PROJECT: P-21-0104 - TACO TIME

SITE ADDRESS: 1115 E. MAIN

PROJECT DESCRIPTION (as provided by applicant): SETBACKS REQUIREMENTS; DRIVE-THRU STDS; LANDSCAPING REQUIREMENTS

GENERAL SITE PLAN COMMENTS SUMMARY

① SITE PLAN TEST FIT - OPTION 3
 1/16" = 1'-0"

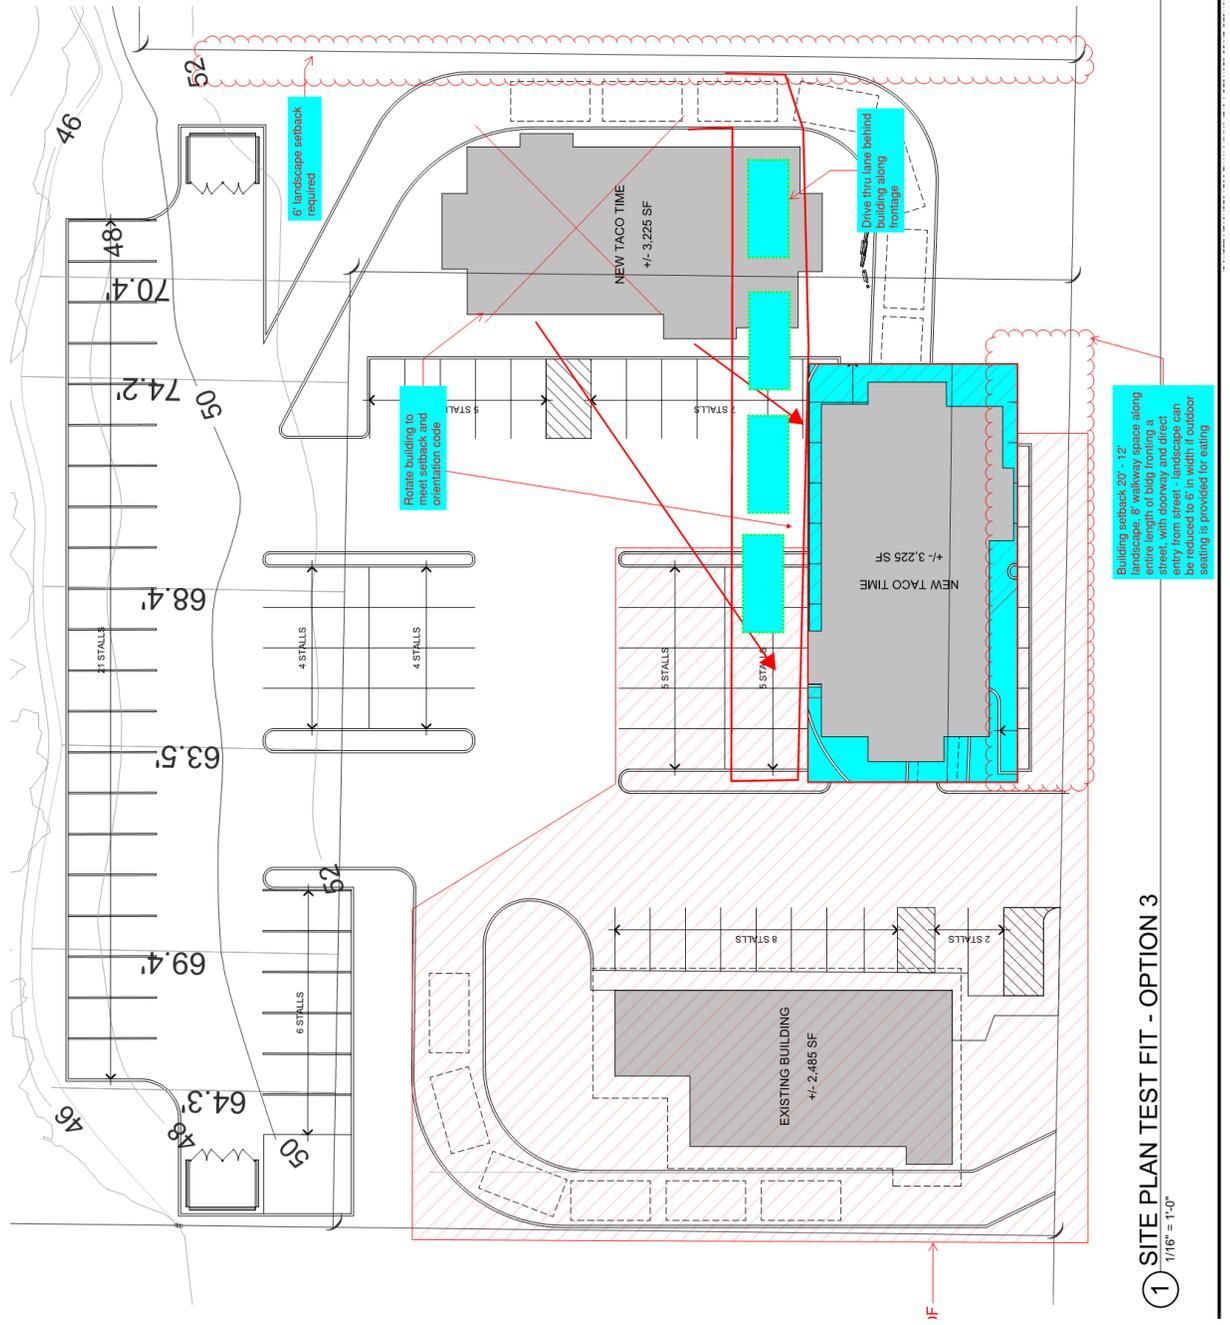
- Buildings have maximum setbacks and orientation/design standards that require street frontage – see PMC 20.30.037. Drive thru lanes need to be located behind the building(s) on site. Please review all code standards for site planning principles and revise the site plan. The following is a mark up sheet to attempt to demonstrate what might work in terms of orientation to meet code:

- The site has well established tree canopy coverage that should be retained – its not clear if the parking lot landscaping is proposed to be modified. The landscaping islands do not meet dimensionally requirements (12-15' width as required by landscaping design requirements – see the type IV landscape details later in these notes) and too many parking stalls are located consecutively without a landscape island (8 max). This will impact the parking count. See landscaping notes.

- The site plan submitted has parking management code for the downtown code shown on the plan sheets; these do not apply to this project.
- The rotating taco time sign on site is non conforming as to height, setbacks and rotating motion signs are not permitted (PMC 20.60.020). If the project plans to remove the rotating sign, the new signage that conforms with current zoning sign code would be required.

- Phase 2 site plan is a very poor design in terms of drive thru queue length for the east building and would not be allowed. Taco Time frequently has 265' of cars in queue based on current observed conditions. Staff did not spend much time with phase 2 site plan to reflect in these notes as it was submitted late and the level of errors with the site plan are substantial.
